Technical Memo:

Review of Custer's Palm Harbor, the Gardens and Palm Harbor Subdivisions

April 2022

Andrew M. Giannini, PE
FL Reg. No. 46601

FIGURE 4-1: NODAL DIGRAM

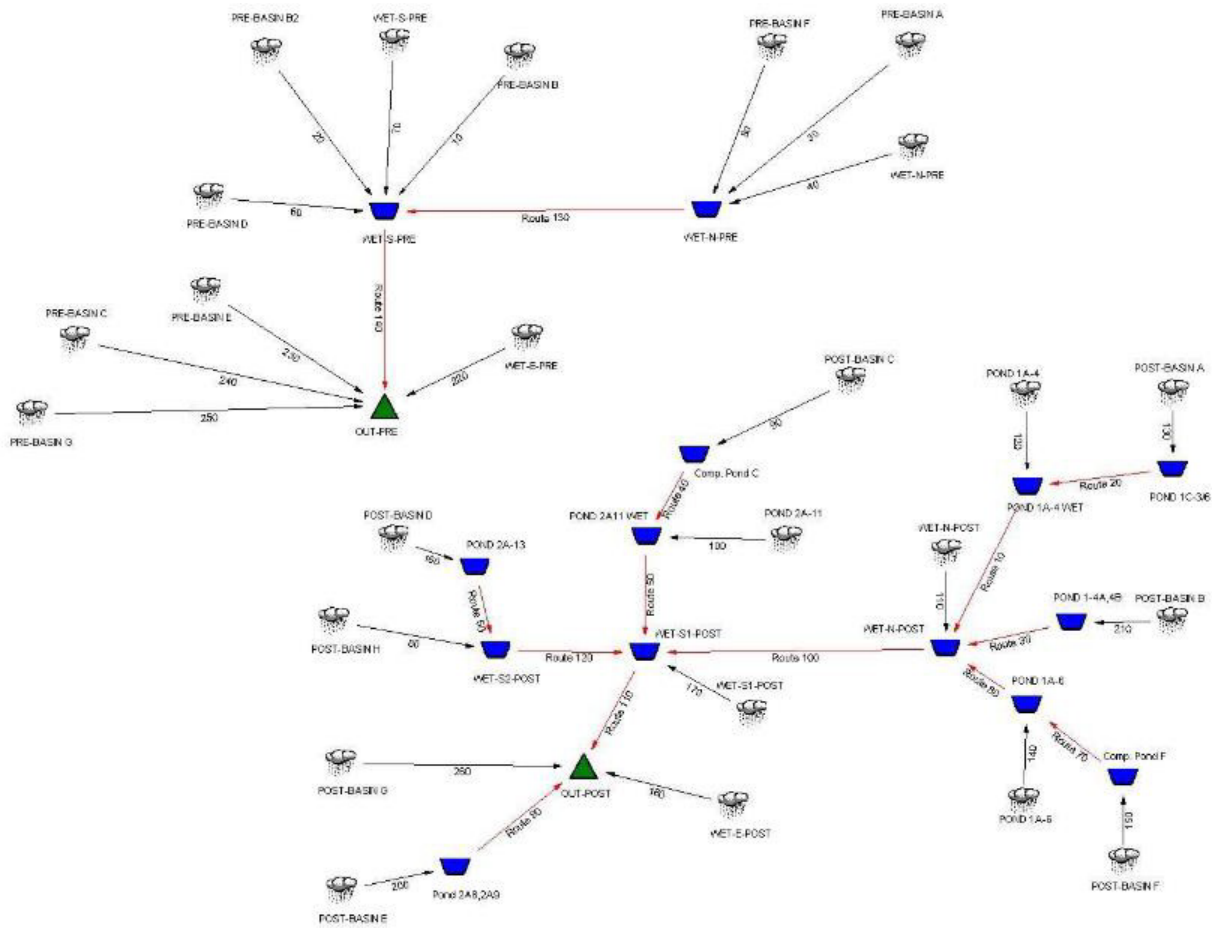
When designing the Gardens drainage system, impacts to the wetlands were greatly avoided, keeping the natural flow of water consistent with predevelopment like conditions. This is shown in the Post development **Figure 4-3**. When looking at the nodal Diagram shown in **Figure 4-1**, it was noticed that the only discharge location considered was the south existing outfall. The model does not consider sending any water north, as shown in **Figures 4-2 & 4-3**. The Existing Modeling Nodal Diagram suggests that all the water captured in Wet-N-Pre and Wet-N-Post (Northern Wetland) is all captured and sent south to the existing south wetland, then discharged through the south outfall point. The following table shows the comparison between the pre-development and post- development peak discharges.

It is recommended that further modeling be completed to show whether the engineer's assumptions are correct. It is suggested that the Wet-N-Pre Post Node (northern wetland) be converted to a storage node to better resemble conditions shown in **Figures 4-2 & 4-3**; and the model include the two 48-inch pipes under Palm Drive that connect to Matanzas River. Doing this will help quantify the amount of water that could head north towards the existing Custer's Palm Harbor community once the Gardens development is completed. It was noted that the developers are currently entertaining costs from construction firms to begin construction in the coming months.

The review of all documents obtained and mentioned in this report, indicates that additional modeling should be performed. The north wetland slough should be modeled as a storage node and the dual 48-inch pipes should be included in the model. This expanded model will allow a better representation of the proposed conditions of the Gardens development.

FIGURE 4-2: PRE-DEVELOPMENT

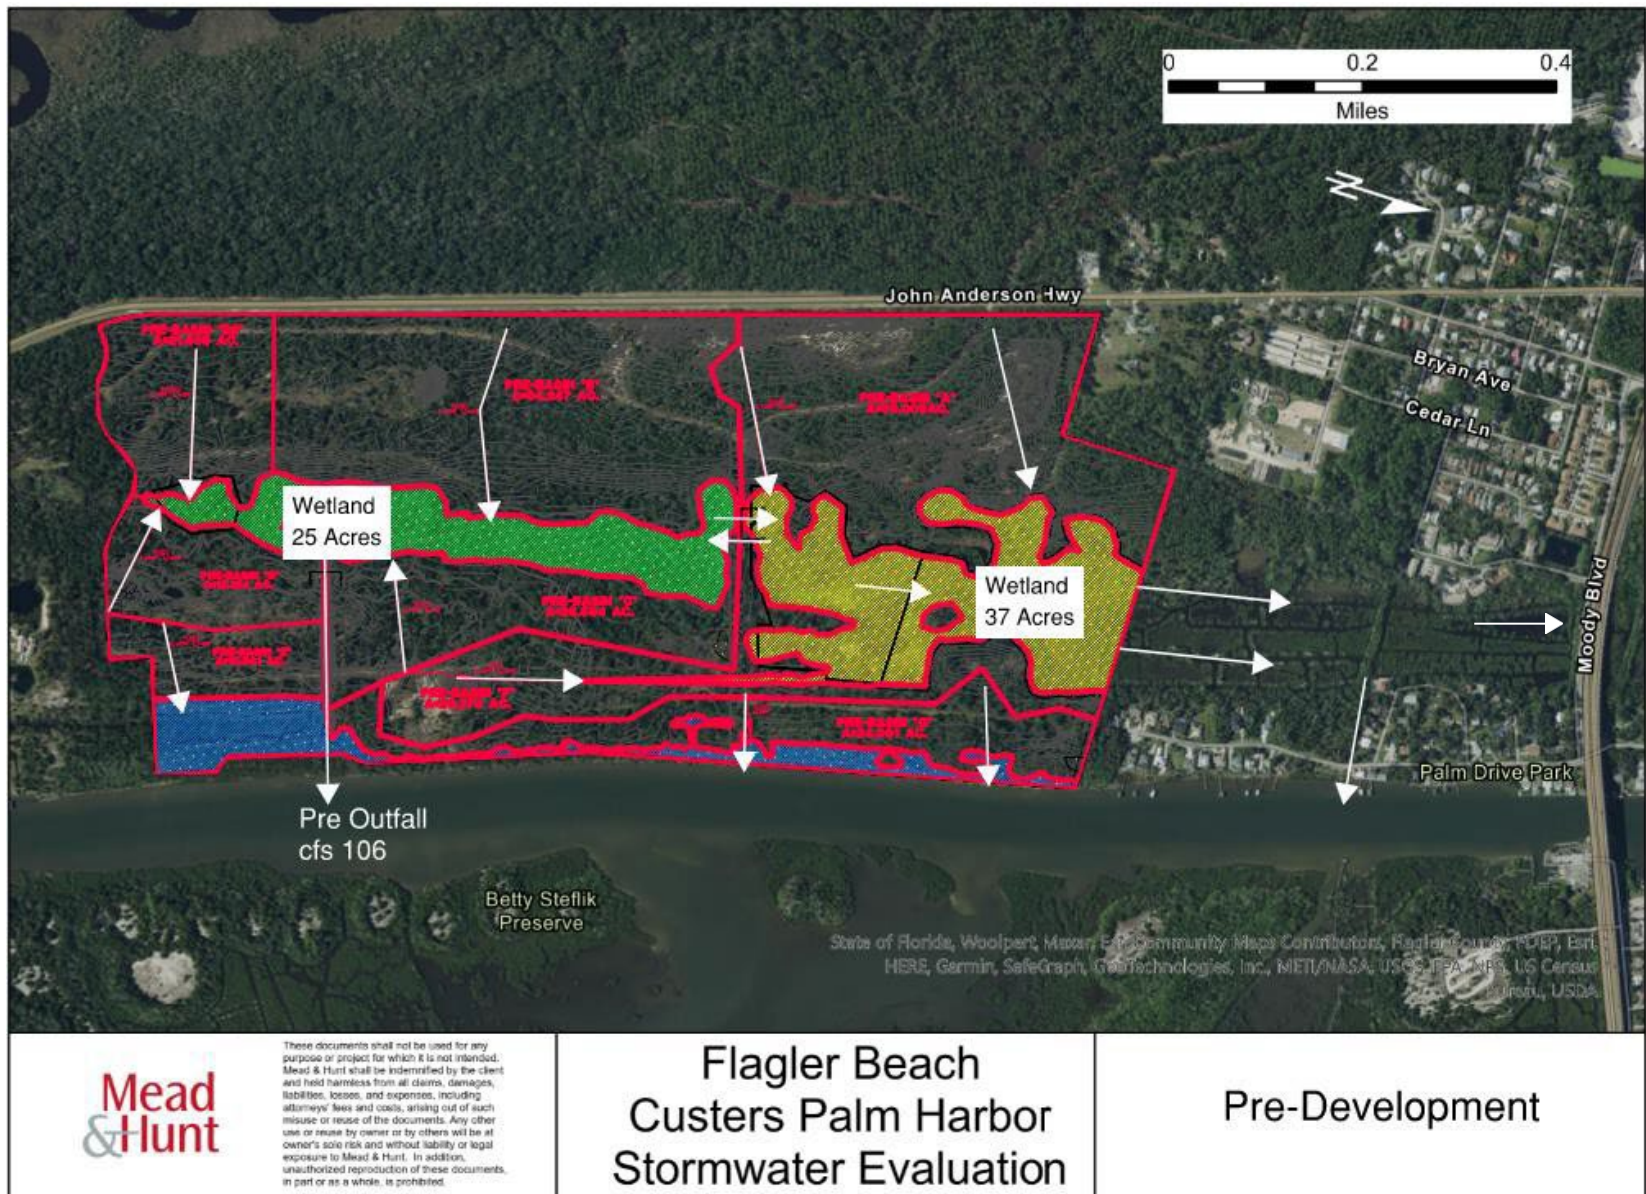
PMA's stormwater calculations and modeling prepared in PondPack Ver 9.0029 were reviewed for the proposed Gardens development. As shown in **Figures 4-2**, the white arrows show the flow of water over the existing area that will be developed into the Gardens community. Most of the water west of the existing wetlands naturally flows east into the wetlands. The water drains from the North and South wetlands through three locations. The first is on the south side through an existing outfall. The second is on the north side through the twin 48" discharge pipes in Custers Palm Harbor, and the third option is that it can flow north under the SR 100 bridge. All of these outfalls eventually reach the tidal influenced intracoastal waterway, or Matanzas River.
